**APPLICATION FOR PERMISSION
UNDER SECTION 16 OF
THE TOWN PLANNING ORDINANCE
(CAP.131)**

Proposed Temporary Training Facilities in San Tin**Application for Permission under Section 16 of the Town Planning Ordinance**

Planning Application No. A/YL-ST/658
Agreement No. CE47/2020 (CE) – Term Consultancy for Site Formation and
Infrastructure Works for Proposed Housing Developments in Zone 2 (2021-2024) –
Feasibility Study, Task Order No. 9 – San Tin
(Application for Permission under S.16 of the Town Planning Ordinance)

| Drawing No. | APP4.3b | Rev. | |

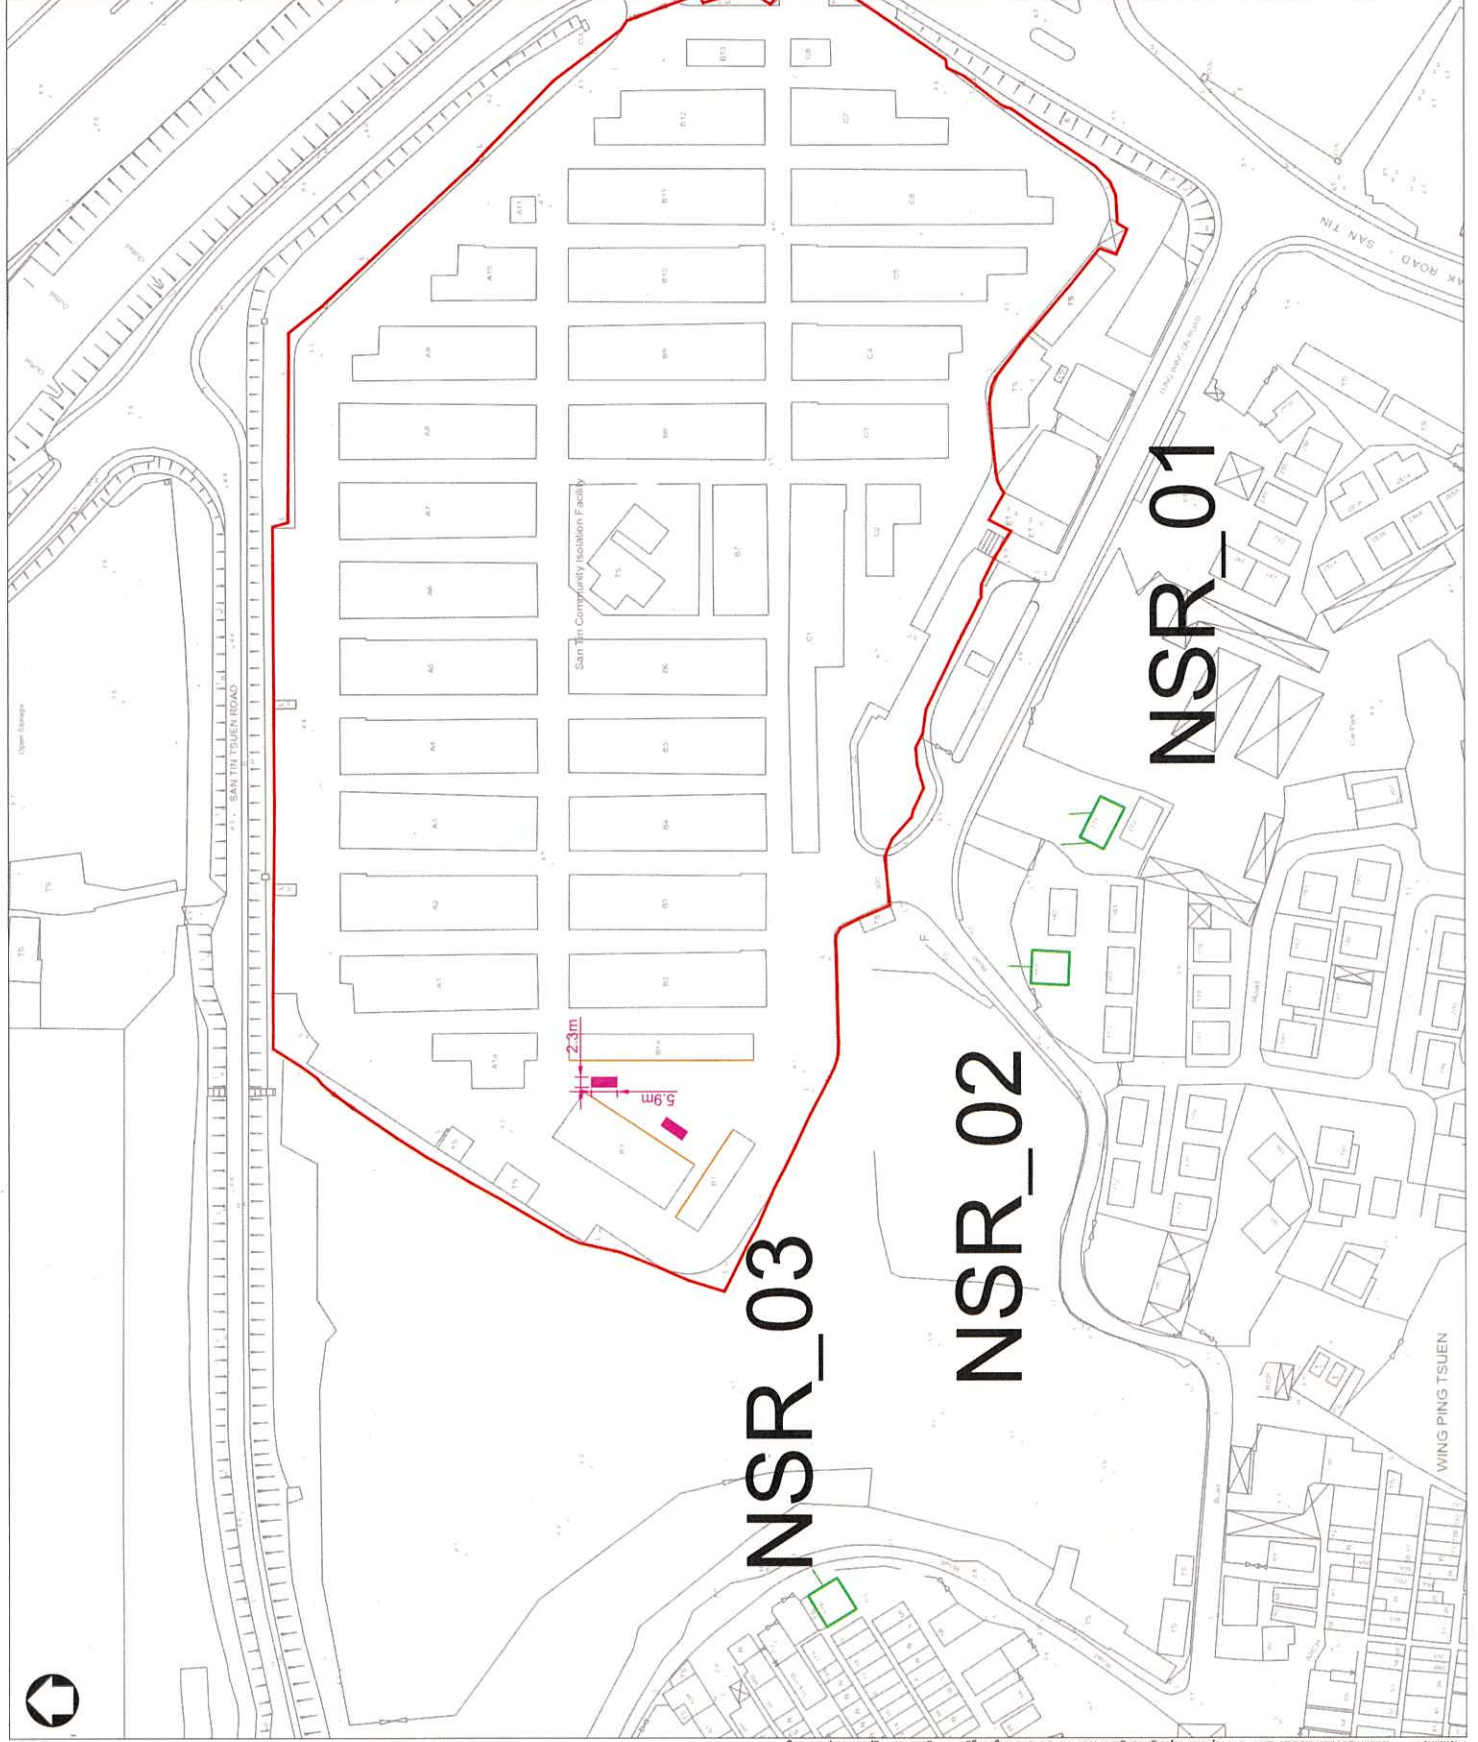
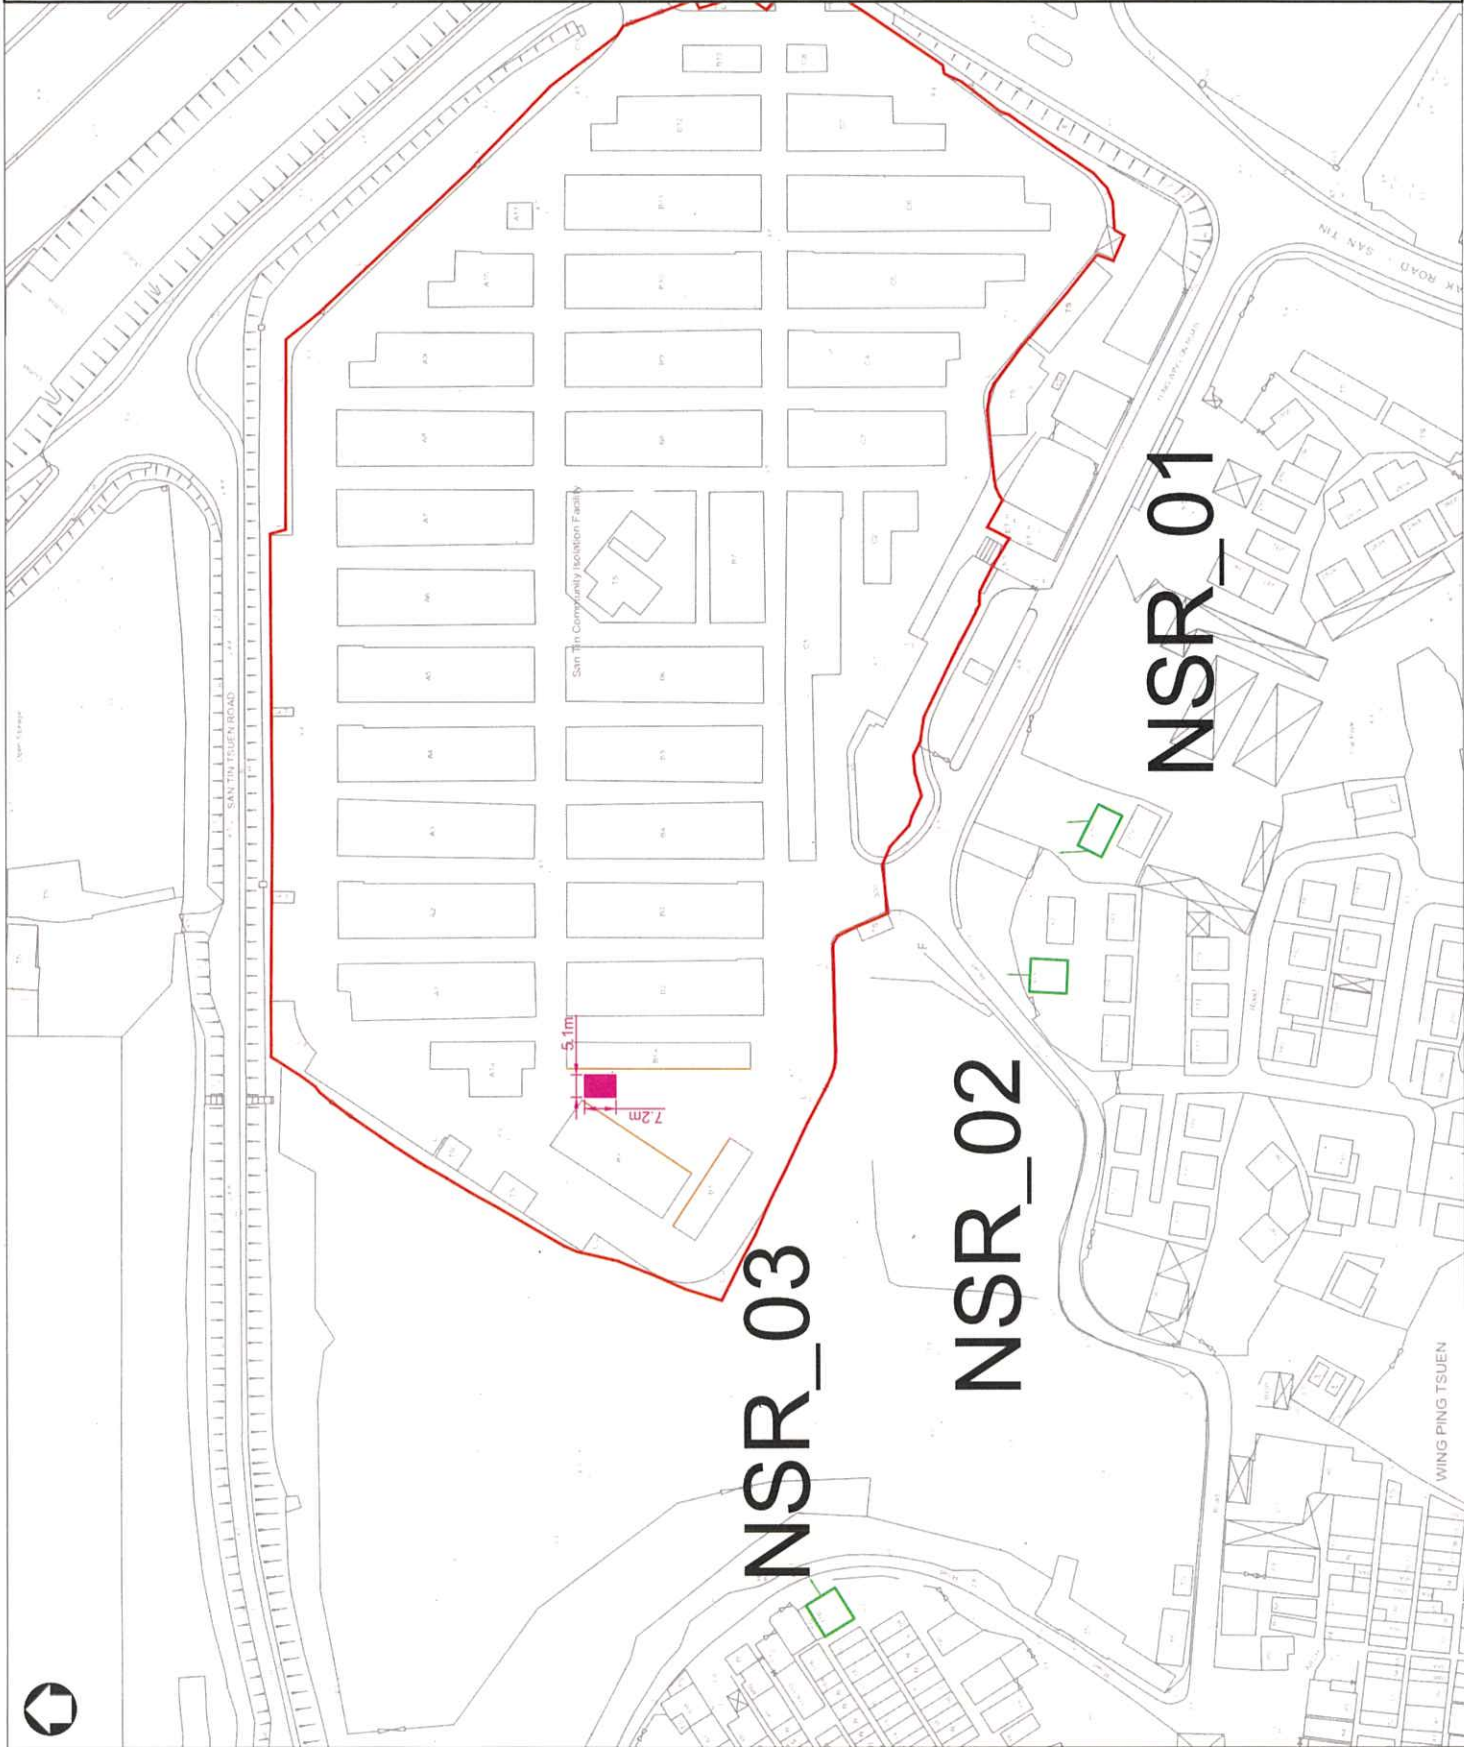
| 4 | Appendix 4.3 – For Option 1, please consider providing two more PME/QPMEs with SWL ≤95 dB(A) for better reference purposes. | Two more PME/QPMEs with SWL ≤95 dB(A) are added into the revised Appendix 4.3. |

| 9 | <p>Appendix 4.3</p> <p>It seems that the sizes of the mobile cranes in Option 2b, 2c and 3 have been under-estimated. Please double-check.</p> | The sizes of the mobile cranes in Appendix 4.3 have been revised. |
